RE: Ewing Gravel Pit, DRMS File M2023-033
Adequacy Response 1

The attached letter addresses each adequacy item in your December 11, 2023 letter regarding the Ewing Gravel Pit. Items marked as adequate are omitted. Revised exhibits and maps are attached as well. Feel free to contact my office with any questions.

Map F-2 Flow Structures

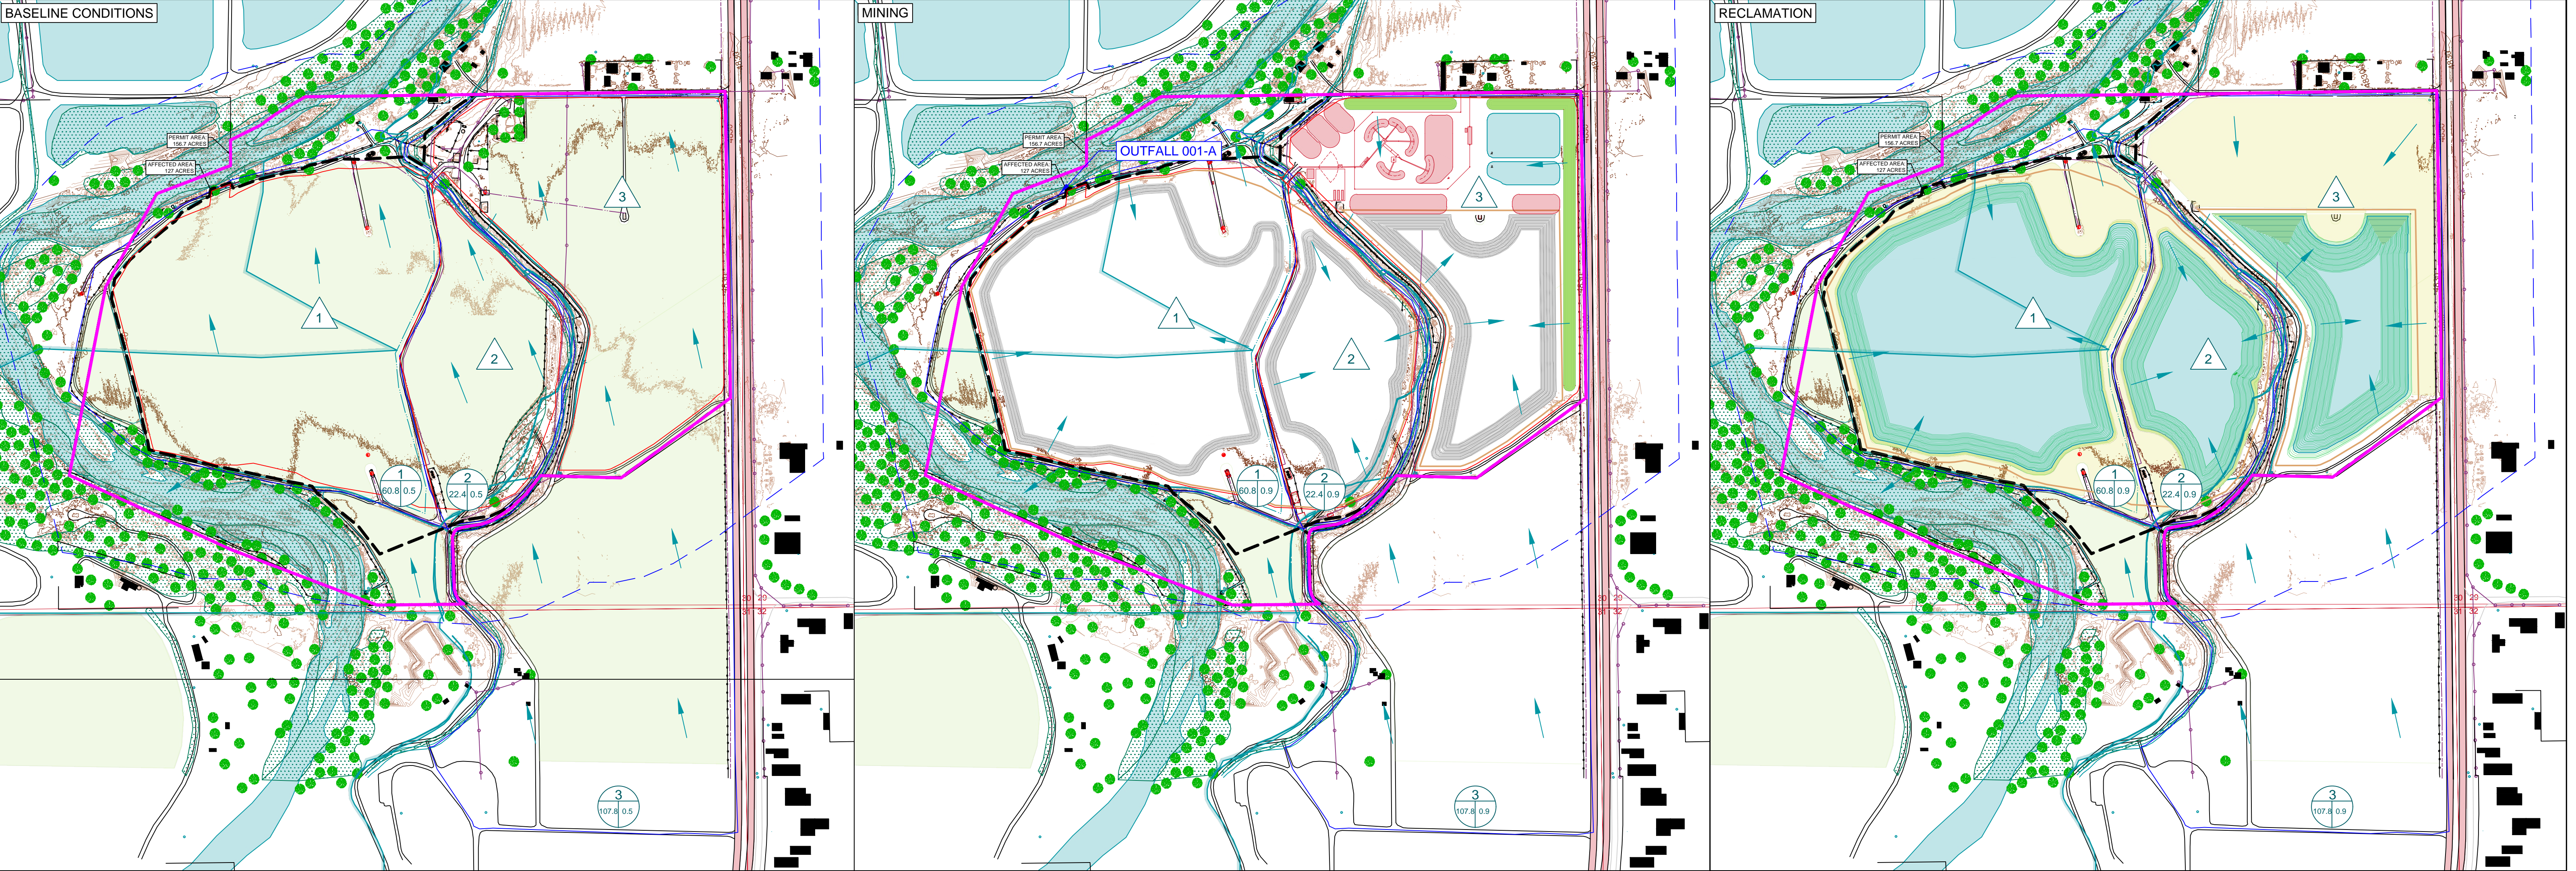
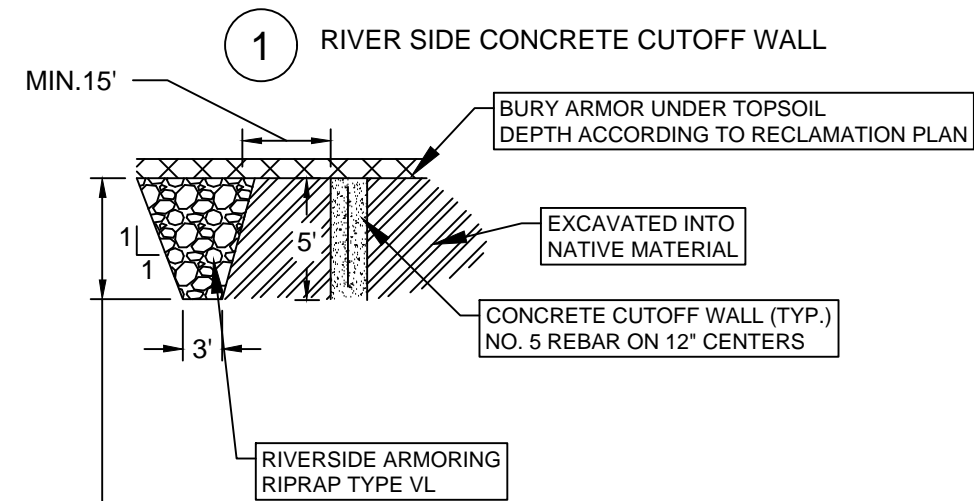
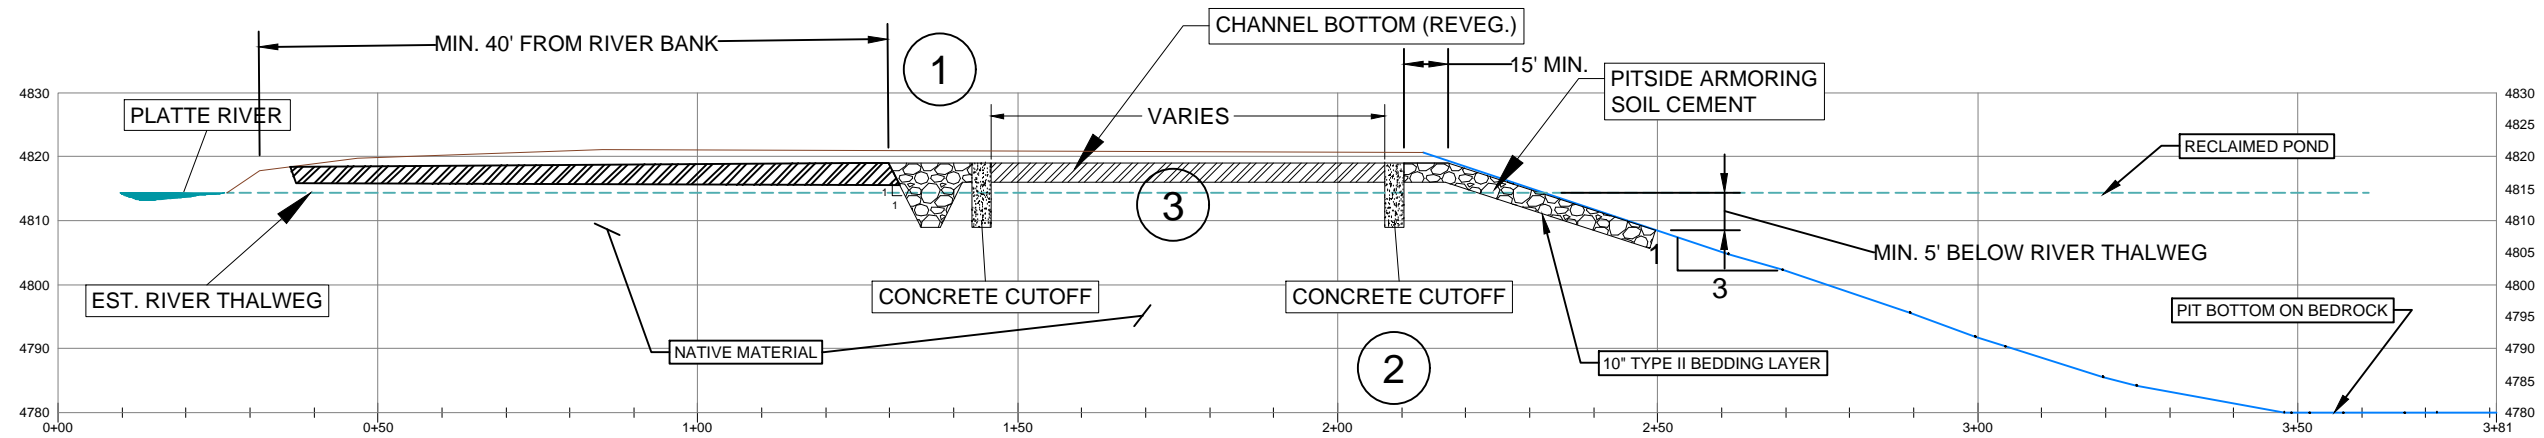
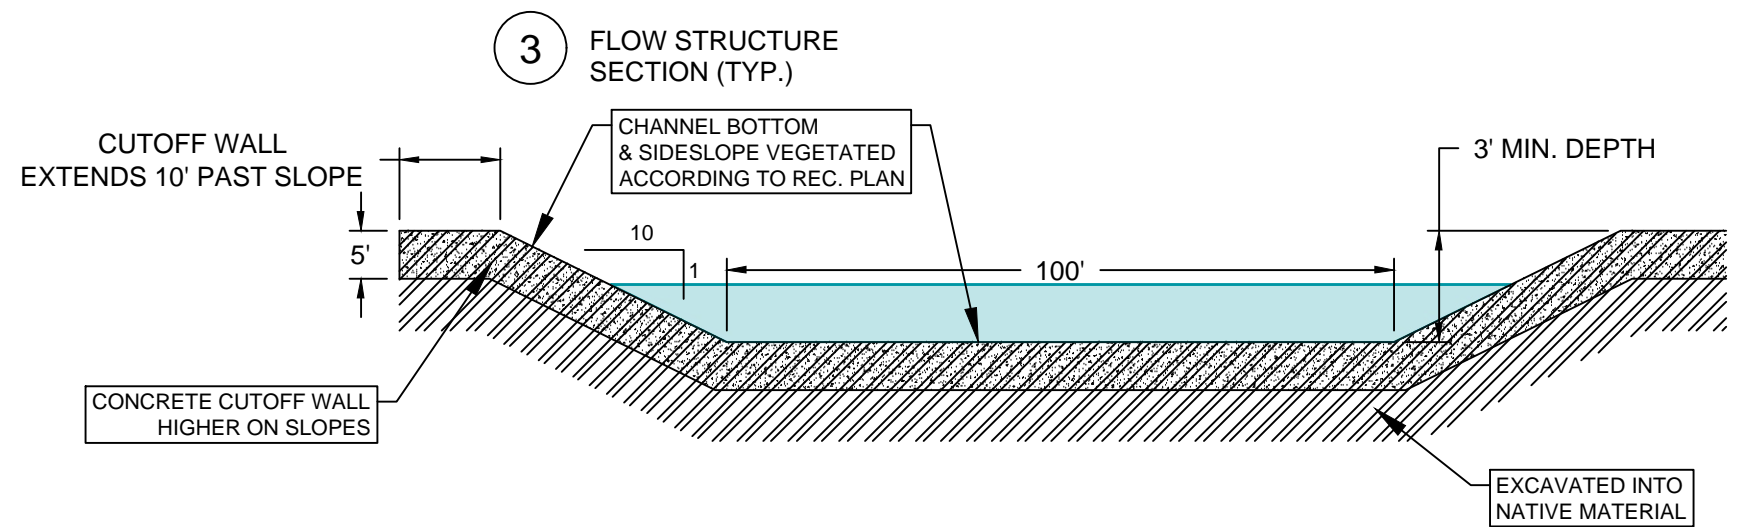
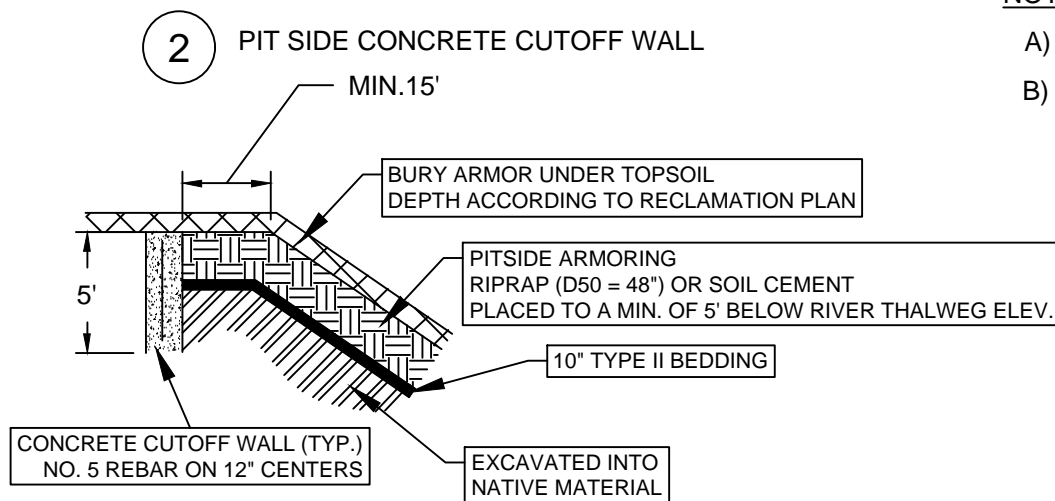
- 9) *Mining will begin in Pod 1 proceeding west to east as depicted on the Mining Plan Map. The application states that the active mining face will not exceed 500' in length, and that the flood control inlet/outlet structures will be installed when mining reaches within 300' of the river bank.*

Therefore, site specific designs, specifications, installation costs, as well as US Army Corps of Engineers approval for the construction of these flood control features, will need to be provided prior to commencing excavation activity in Pod 1 – please acknowledge/provide.

A typical design for the flood control structures are included on Map F-2. These structures are designed to avoid any construction within Waters of the United States and are therefore outside of the jurisdiction of the US Army Corps of Engineers (USACE). The applicant does acknowledge that if any fill activities take place onsite that are within the jurisdiction of the USACE, appropriate permit approvals will be secured before fill activities take place.

Appendix 1 - Map

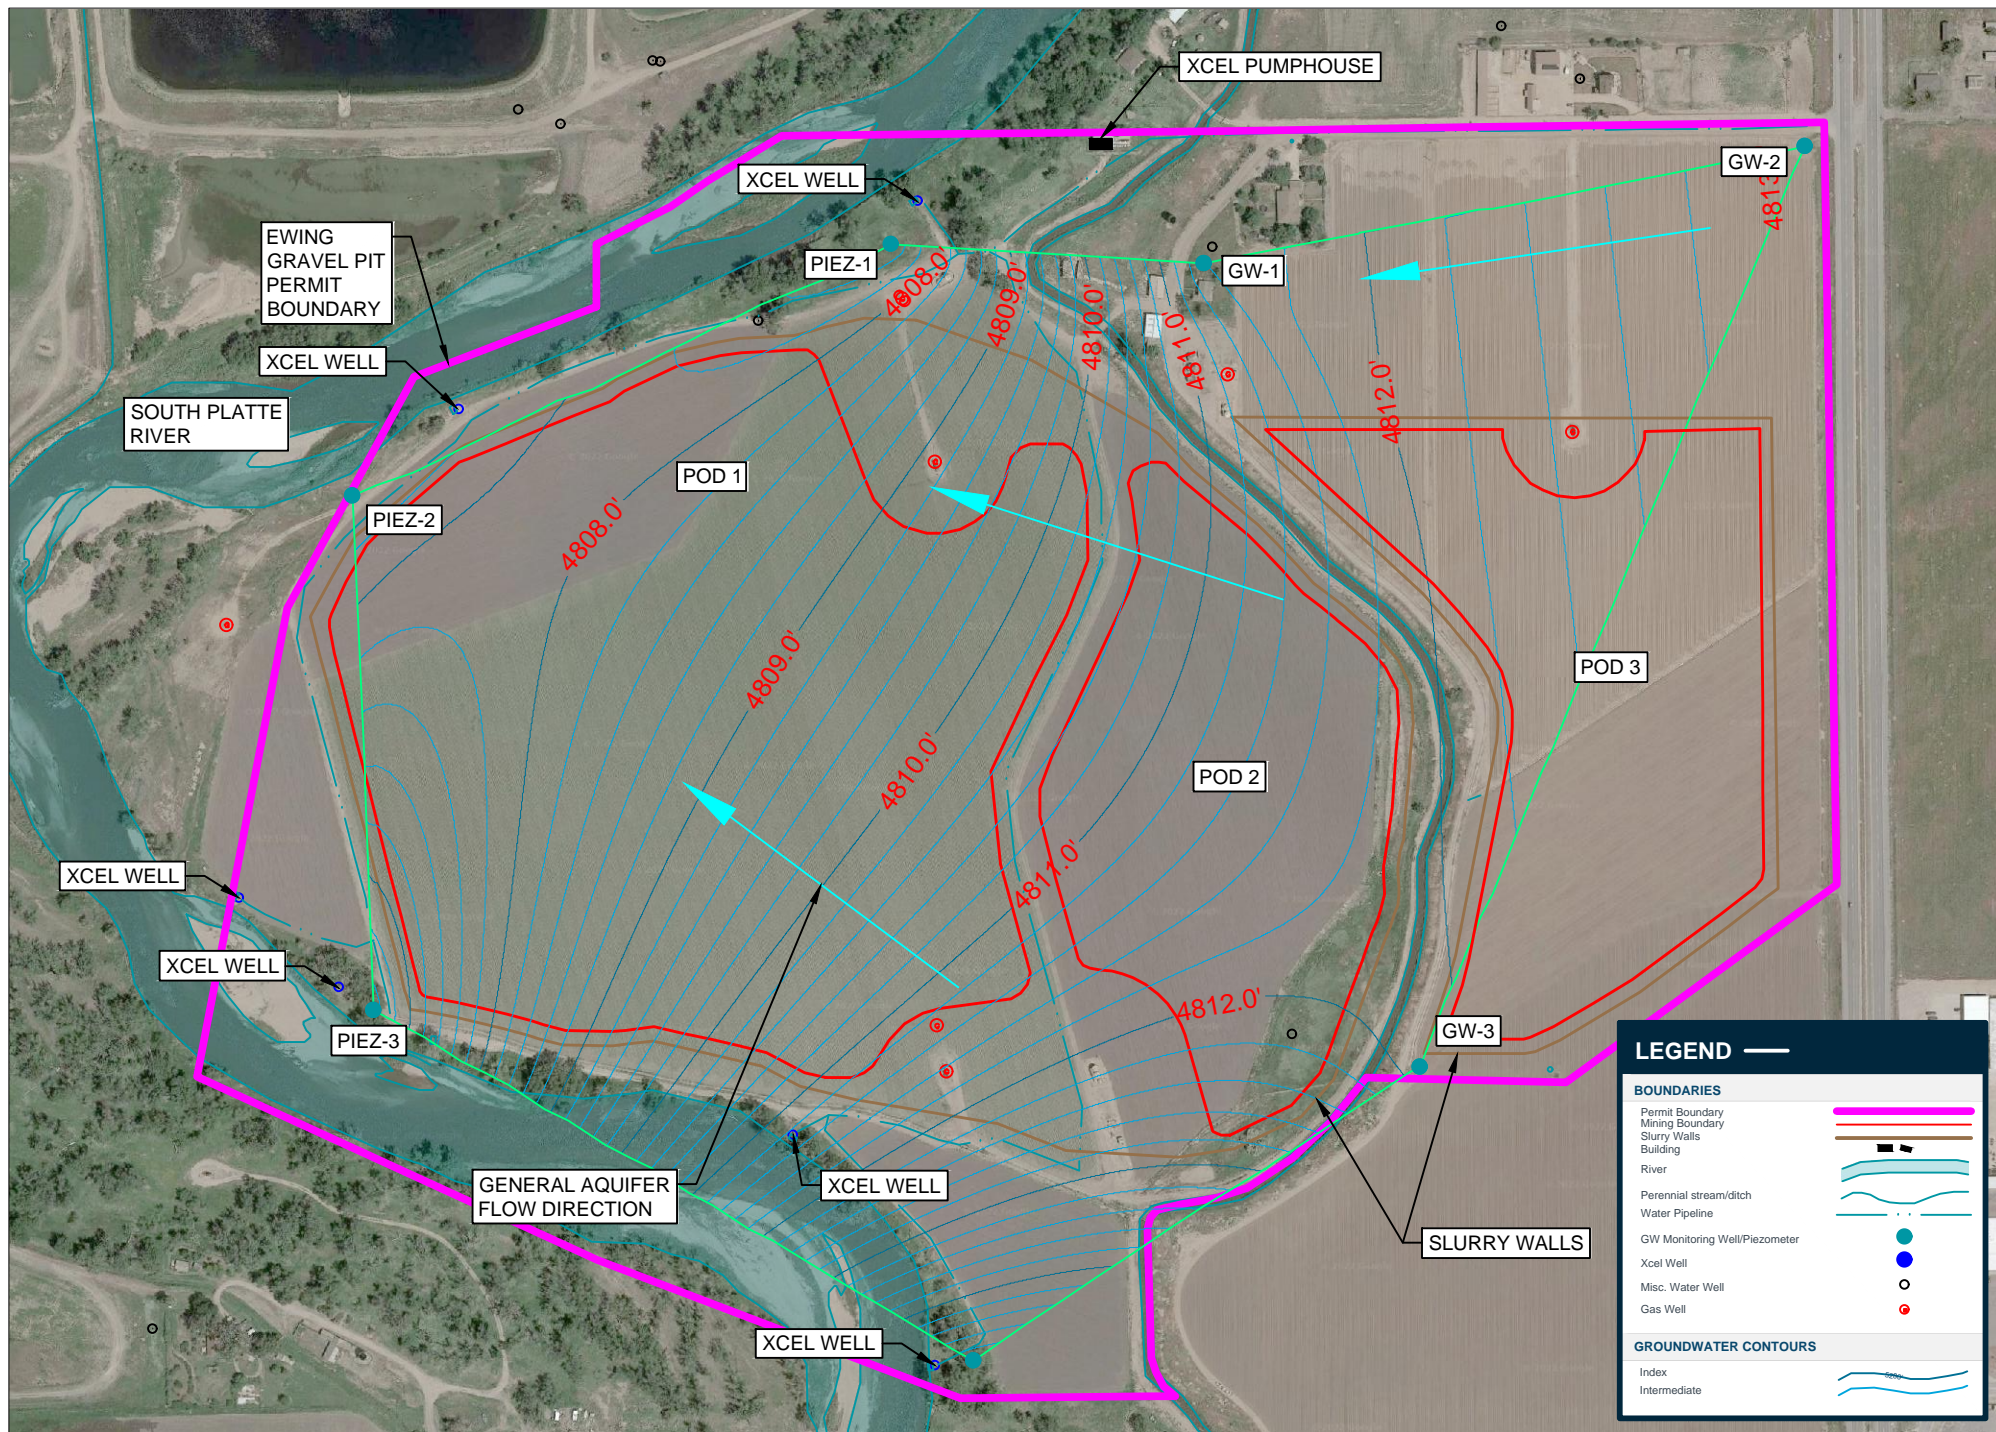
- 15) *The well locations identified in Table G-4 are very difficult to find/identify, or are not shown on Figure C-1. Please provide another map to clearly show the wells listed, as well as the XCEL wells in Table G-5, and the 4 piezometers listed in Table G-6.*

Please the Groundwater Monitoring Map in Appendix G-1 which has the location of the requested wells.
